## Application for Licence Amendment

<b>Licence Number</b>	L4762/1972/14
<b>Licence Holder</b>	Pilbara Iron Company (Servies) Pty Ltd
<b>ACN</b>	107 210 248
<b>File Number</b>	DER2013/001057-2
<b>Premises</b>	Greater Tom Price Iron Ore Mine  Legal description –  Mining tenements ML4SA, G47/1258, G47/1260, L47/161, L47/209, L47/210, L47/342, L47/552, L47/645, L47/668, L47/698, L47/721, G47/1271, L47/745, L47/824, L47/826, and L47/858.  MOUNT SHEILA WA 6751  As defined by the coordinates in Schedule 2.
<b>Date of Report</b>	28/11/2024 (FINAL)
<b>Decision</b>	Decision to grant licence amendment

Figure 2: Distance to sensitive receptors

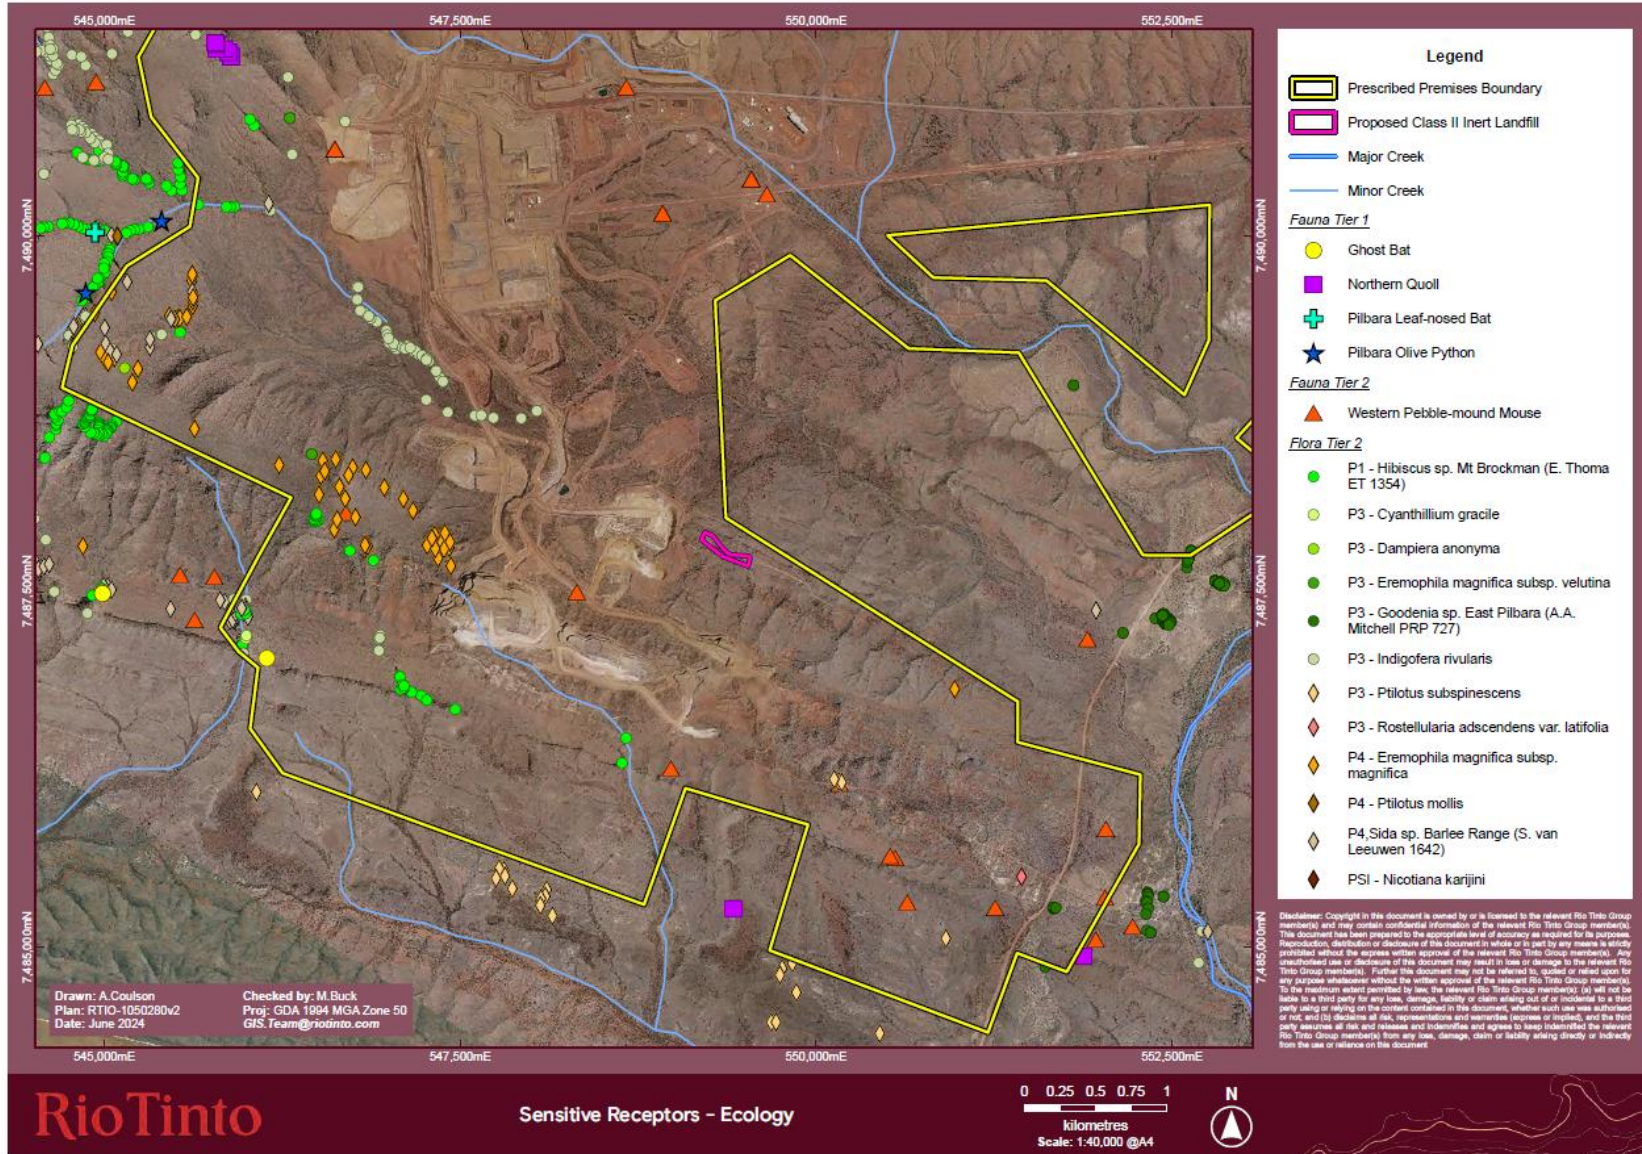
Table 5 below provides a summary of potential human and environmental receptors that may be impacted because of activities upon or emission and discharges from the prescribed premises (*Guideline: Environmental siting* (DWER 2020a)).
